Application for Works Approval

Works Approval Number W6845/2023/1

Applicant BP Refinery (Kwinana) Pty Ltd

Premises BP Kwinana Energy Hub
1 Mason Road,
KWINANA BEACH WA 6167

Figure 2: Worst case night time noise contours for scenario 2

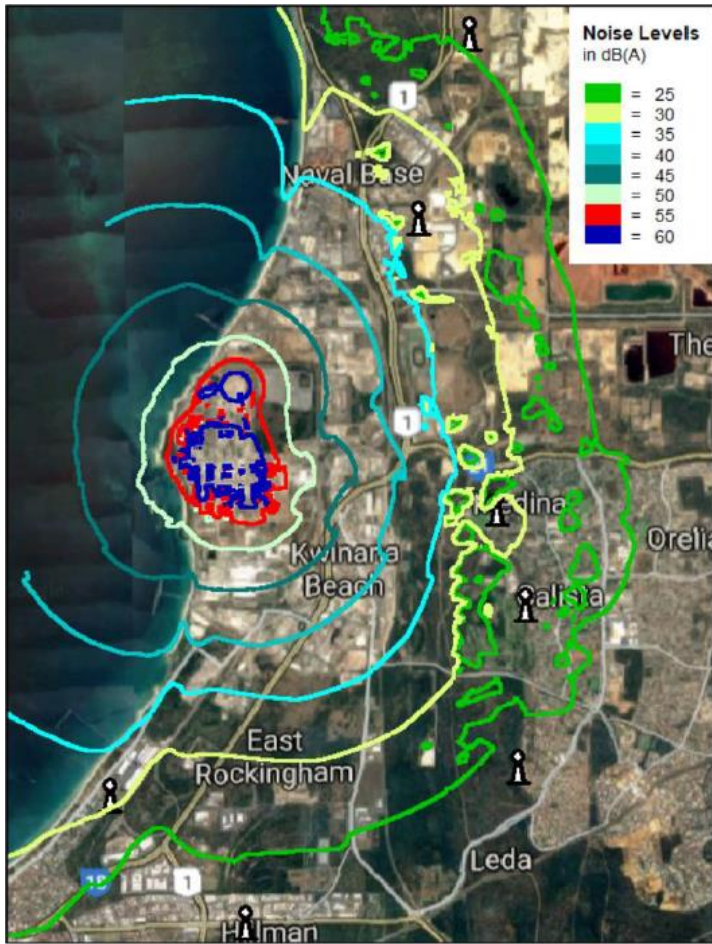
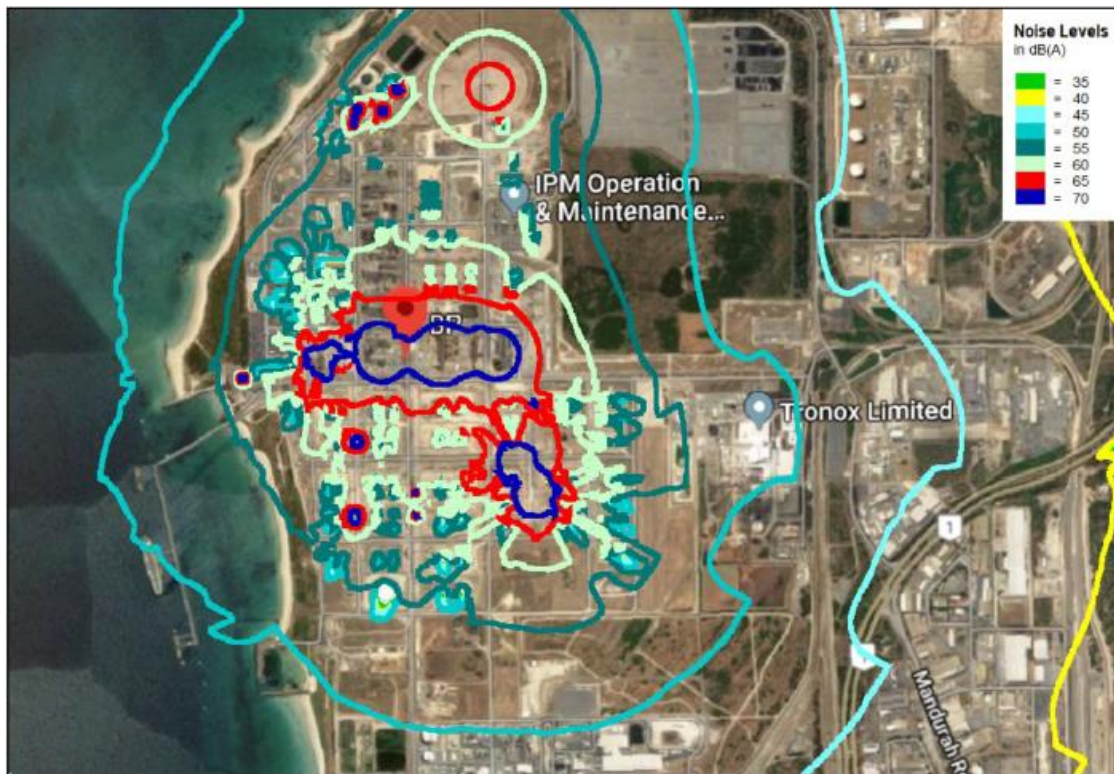
A technical review of the noise impact assessment was conducted by the department and determined that:

- The noise modelling and conclusions seem reliable and acceptable; and
- The modelled operational scenarios seem reasonable.

The technical review noted however that the proposal as assessed and considered in the noise impact assessment was in the early design stage and that actual noise emissions will likely need to be monitored under operational stages to confirm the noise modelling conducted.
